February 1996

86-060-20

TECHNICAL SUPPORT FOR PROPOSED
MODIFICATION TO THE CHURCH ROCK SITE
TAILINGS RECLAMATION PLAN
NRC LICENSE SUA-1475

United Nuclear Corporation

PROPOSED AMENDMENTS TO
FINAL RECLAMATION PLAN
SOUTH END
PREPARED FOR

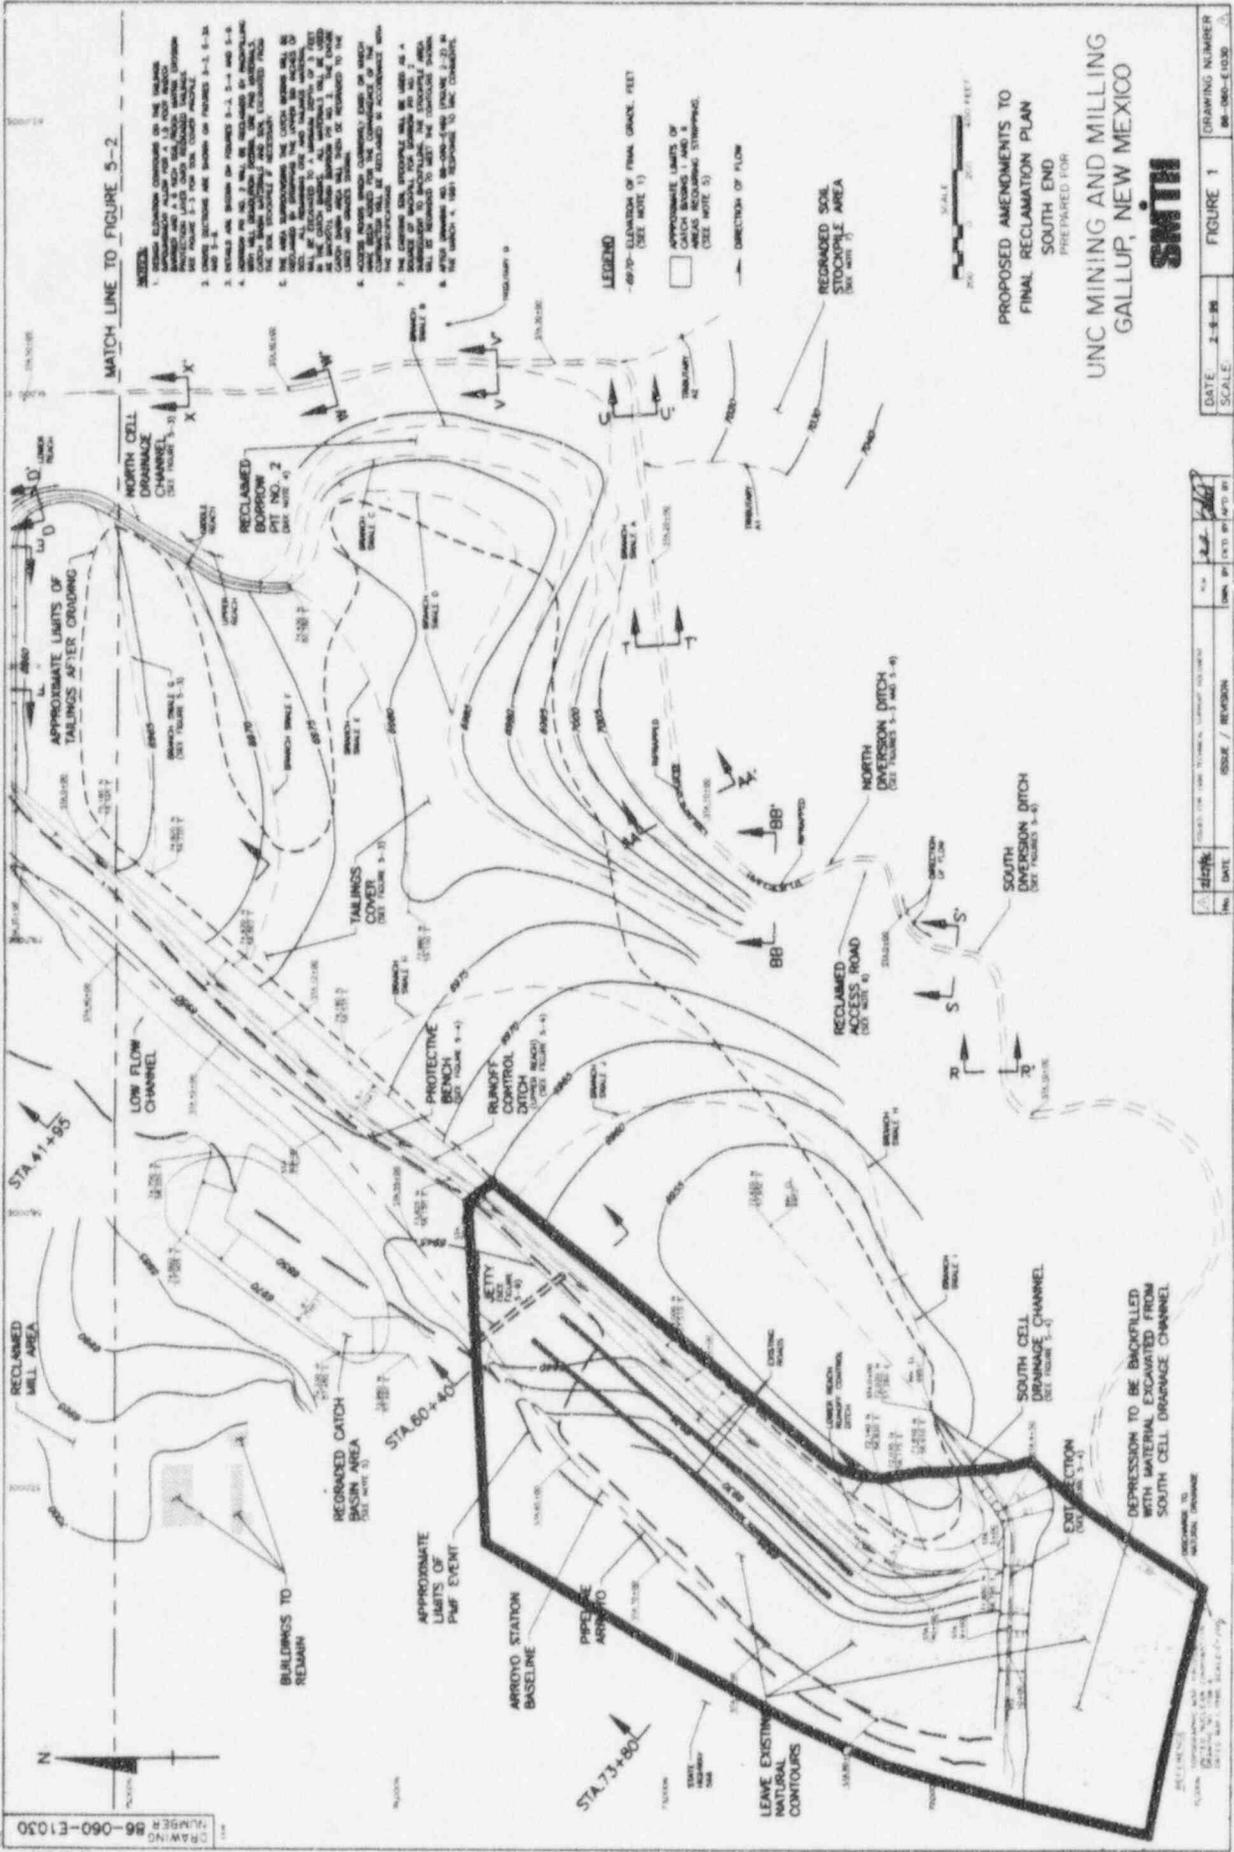
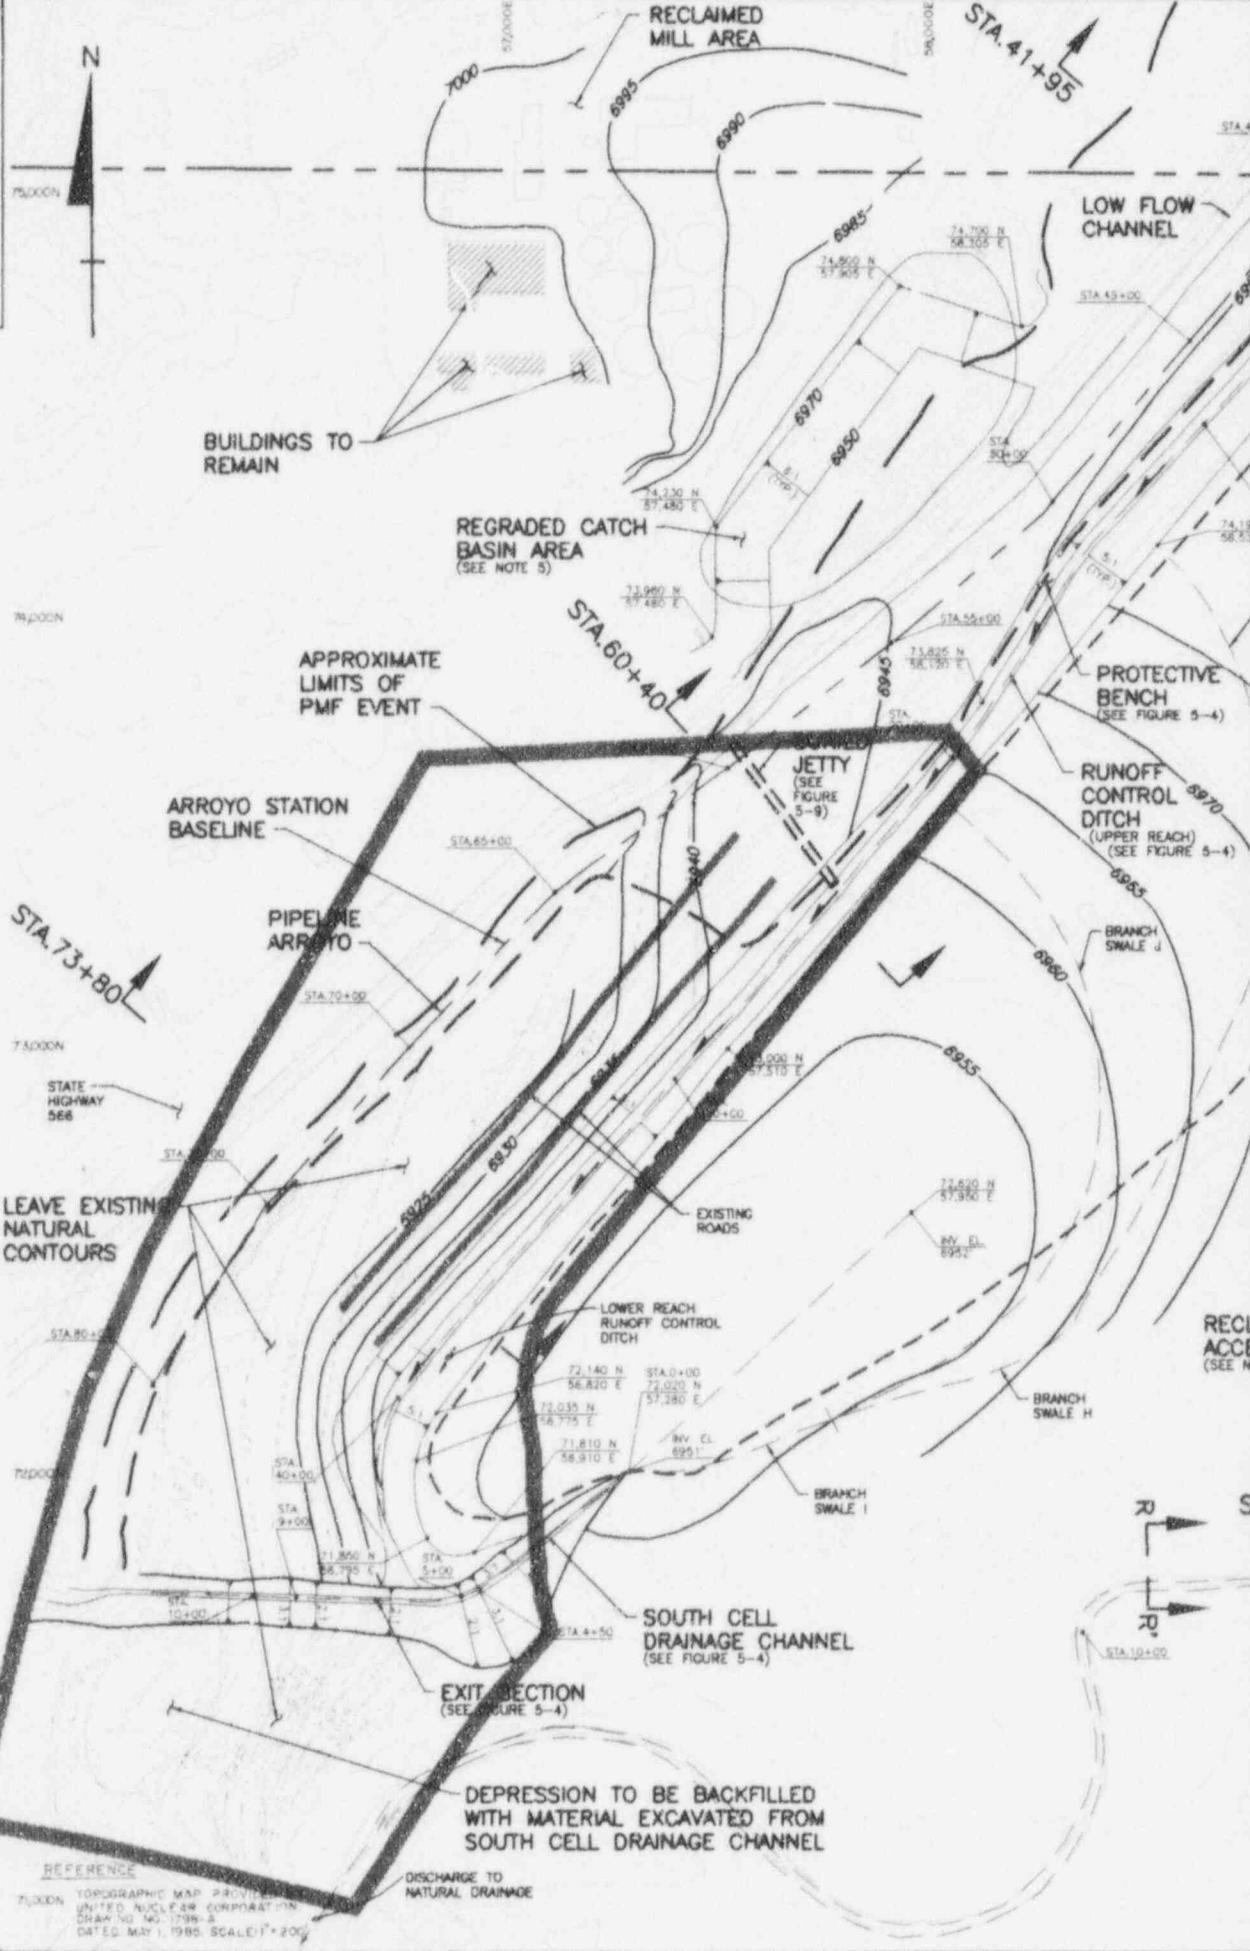
Figure 1 shows that the engineered contours result in a slope to the west and southwest allowing runoff to drain from the tailings to the arroyo. The engineered slope ranges between 1V:10H and 1V:40H in these areas. The existing natural contours produce the same general effect as the engineered contours with the exception that runoff drains to the south-southwest.

Removal of the existing roadways located at the base of the recontoured tailings embankment (highlighted on Figure 1) will smooth out the surface irregularities and allow for a smooth transition for surface drainage from the tailings embankment to the natural surface drainage in this area. Also, the depression located south of the South Cell Drainage Channel (SCDC) will be backfilled with material excavated from the SCDC. The backfill will be contoured to maintain the natural drainage towards the SCDC and the Arroyo. This approach reduces the amount of required earthwork without sacrificing the surface drainage characteristics of the Reclamation Plan.

DEPRESSION TO BE BACKFILLED WITH MATERIAL EXCAVATED FROM SOUTH CELL DRAINAGE CHANNEL

FINAL RECLAMATION PLAN SOUTH END

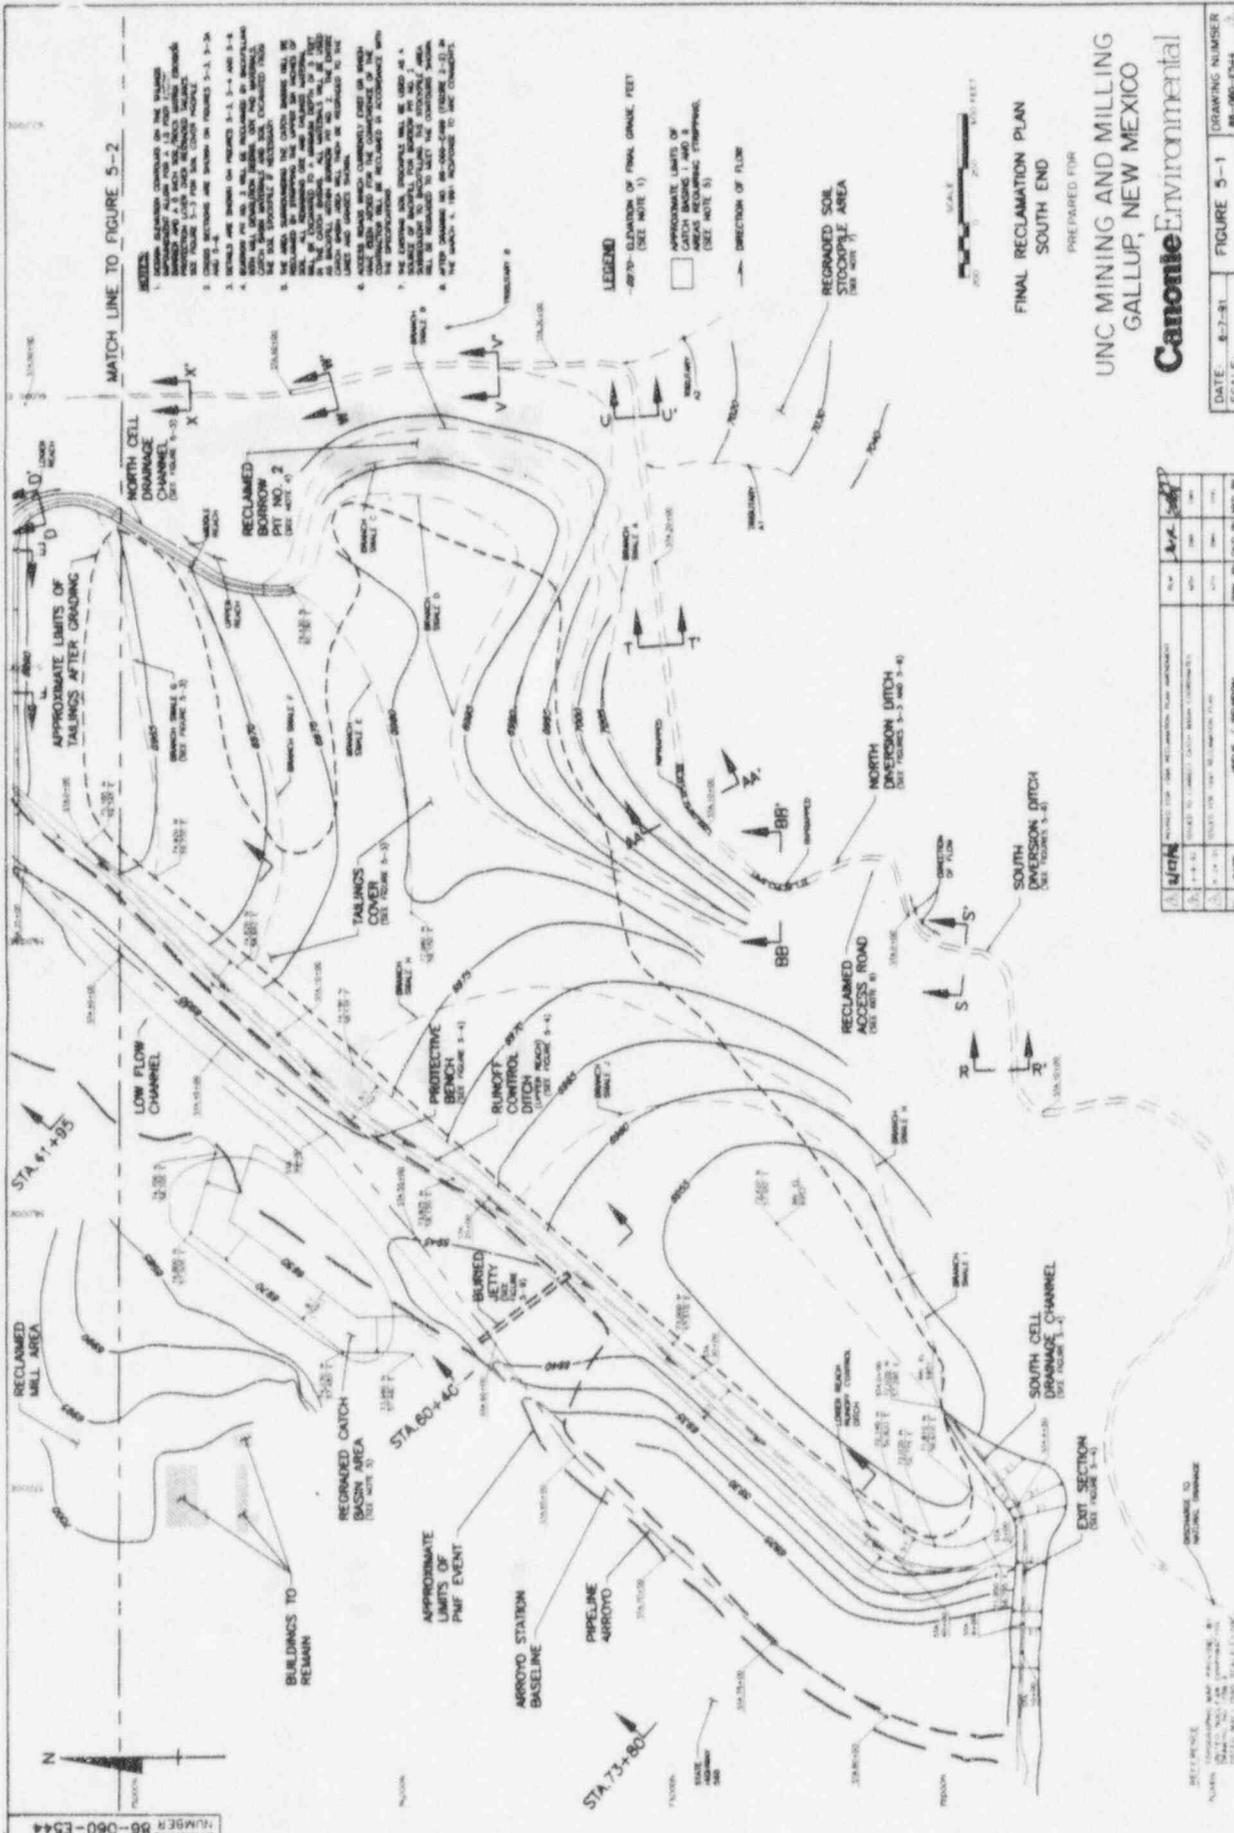
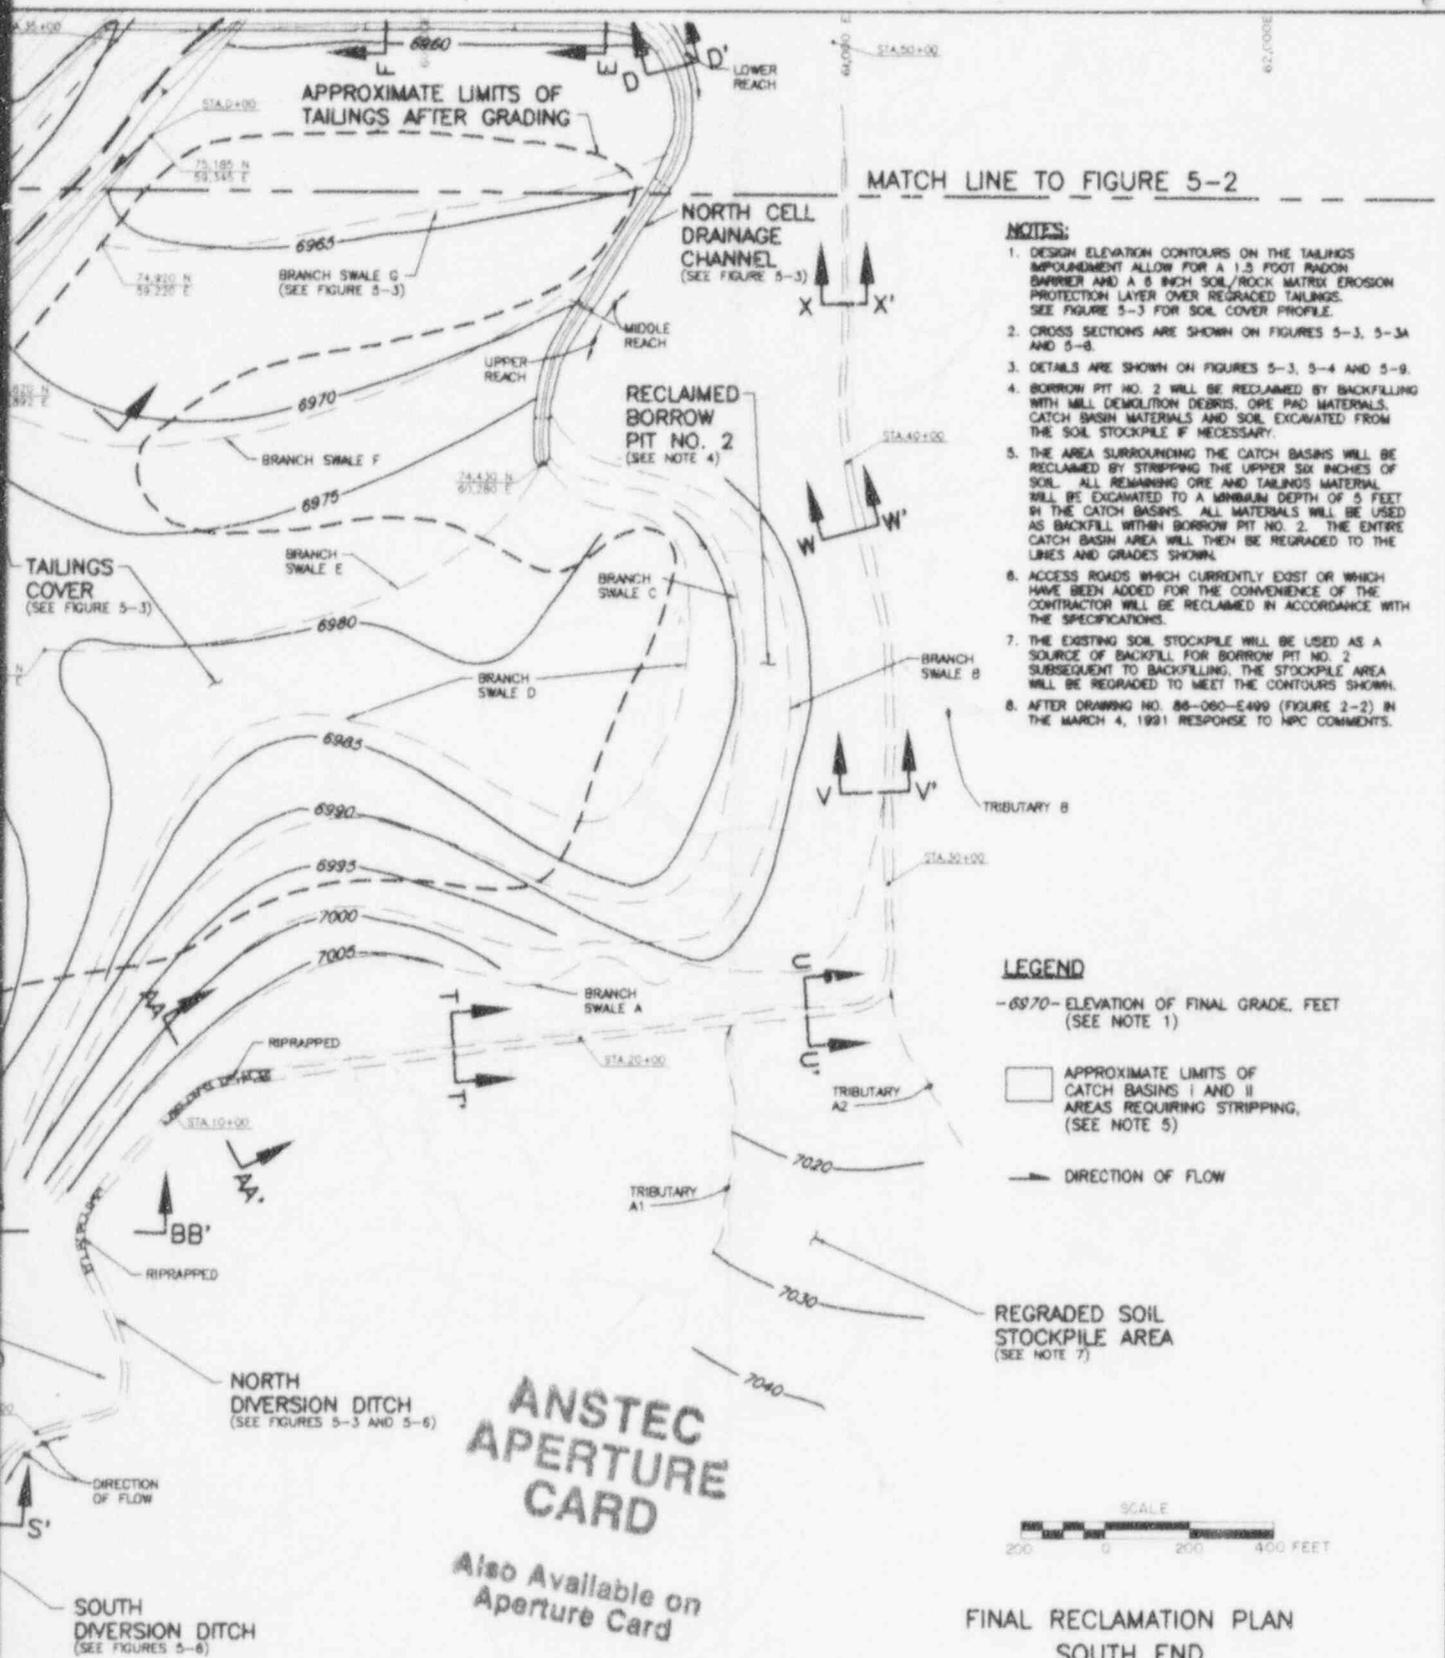
A revised Figure 5-1, showing the approximate final contours for this area is included as an attachment.
